**MONTGOMERY COUNTY PLANNING DEPARTMENT**  
THE MARYLAND-NATIONAL CAPITAL PARK AND PLANNING COMMISSION

**MEMORANDUM**

**REVIEW TYPE:** Preliminary Plan of Subdivision

**PROJECT NAME:** Cabin John Park

PRELIMINARY PLAN  
CABIN JOHN PARK  
SECTION 4

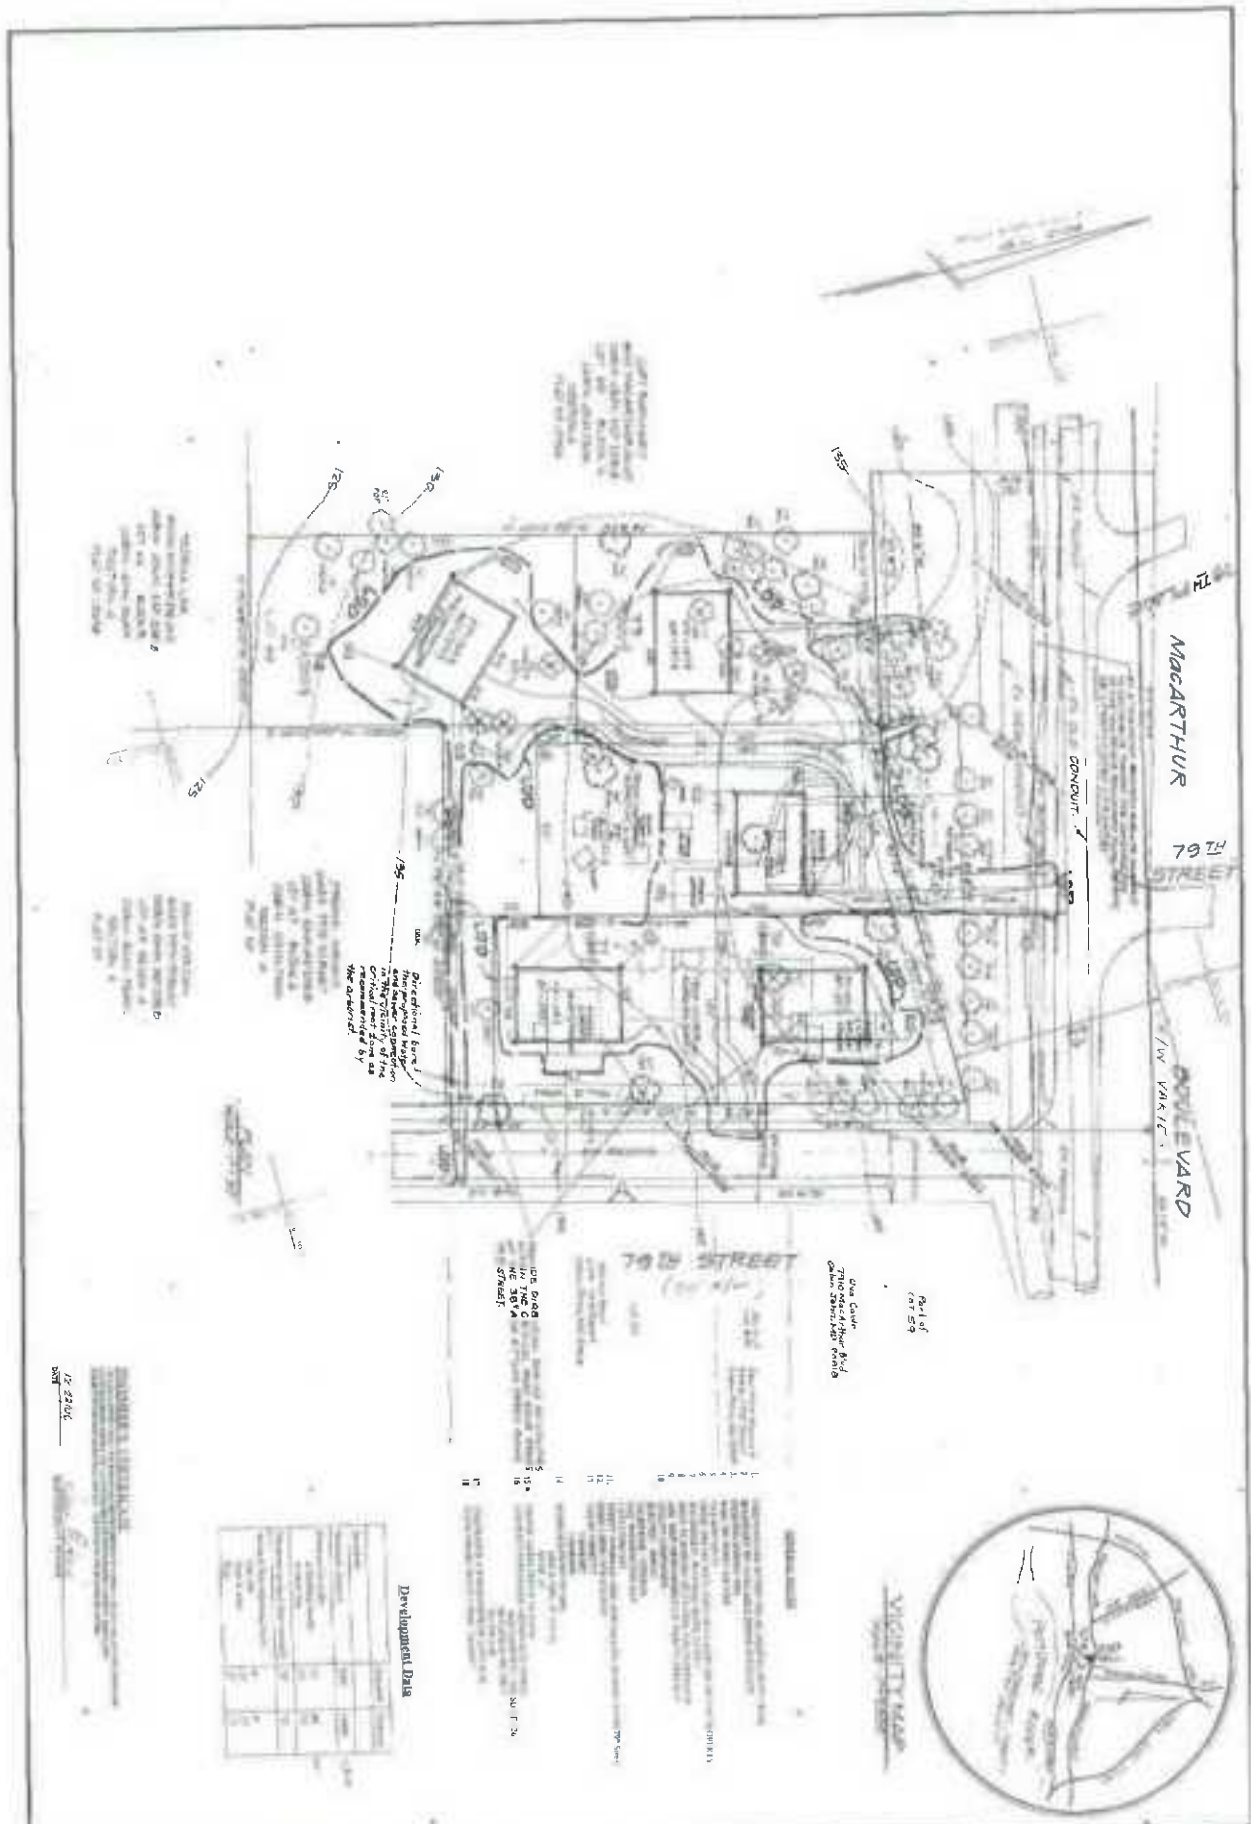
The preliminary plan proposes a resubdivision of the three lots into five single family residential lots. Two of the lots will front to 79<sup>th</sup> Street and two will front to MacArthur Boulevard. The fifth lot will be a pipestem lot to the rear of the other four lots. Three of the homes will access MacArthur Boulevard with a shared driveway and the other two will access 79<sup>th</sup> Street with a shared driveway. Lot sizes range from 11,800 square feet to 24, 700 square feet. All public utilities are readily available to the site including, water and sewer, electric, gas, CATV, and telephone.

The driveway for the two lots on 79<sup>th</sup> Street has been located so as to minimize impact to two trees, specifically the 58 inch oak and the 47 inch oak. The preliminary plan and Tree Save Plan establish limits of disturbance to provide additional tree protection measures. The trees can be saved during construction; however, no long term protection easements are recommended for these trees. One is in the public right-of-way for 79<sup>th</sup> Street; the other is in the public utility easement established by this plan and subsequent plat. While this plan does not anticipate the removal of these trees, there is no guarantee that the trees will survive future road improvements or utility construction.

The applicant has prepared and submitted a tree save plan for many of the large and specimen trees that are to remain standing. The plan also identified at least 15 trees less than 24 inches dbh and greater than 15 inches dbh to be saved. Staff believes the tree save plan needs to be expanded to identify specific tree protection measures for all trees 15 inches dbh that have more than 30 percent of their critical root zone impacted by the proposed development.

An arborist included as part of the tree save plan recommends the removal of tree number 4 a 25-inch dbh pin oak because of several structural defects with the tree. The NRI/FSD identified this tree in poor condition. It should be removed. The arborist report also recommended the removal of tree #9 a 28-inch dbh white oak because of an extreme lean and proximity to a future house. The NRI/FSD identified this tree in fair-poor condition. It should also be removed.

The tree save plan submitted recommends tree protecting fencing, root pruning, mulching, pruning and cabling for the trees to be saved. For high impact trees, such as trees 1, 2, 3, and 5 the arborist report recommends additional tree protection including root aeration matting, subsurface fertilization, supplemental watering, and seasonal integrated pest management plan. The arborist recommends a multi-year maintenance plan to inspect all retained trees for soil moisture; weeds; insects and diseases; granular and liquid bio-stimulation; and hazard pruning of dead, dying, and declining limbs.

- 1) Approval under this preliminary plan is limited to five (5) lots.
- 2) The applicant must comply with the conditions of approval for the preliminary forest conservation plan, including revisions to the Tree Save Plan. The applicant must satisfy all conditions prior to recording of plat(s) or Montgomery County Department of Permitting Services (MCDPS) issuance of sediment and erosion control permits, as applicable.

- 3) The record plat must reflect common ingress/egress and utility easements over all shared driveways.
- 4) The applicant must comply with the conditions of the Montgomery County Department of Public Works and Transportation (MCDPWT) letter dated April 5, 2007, unless otherwise amended.
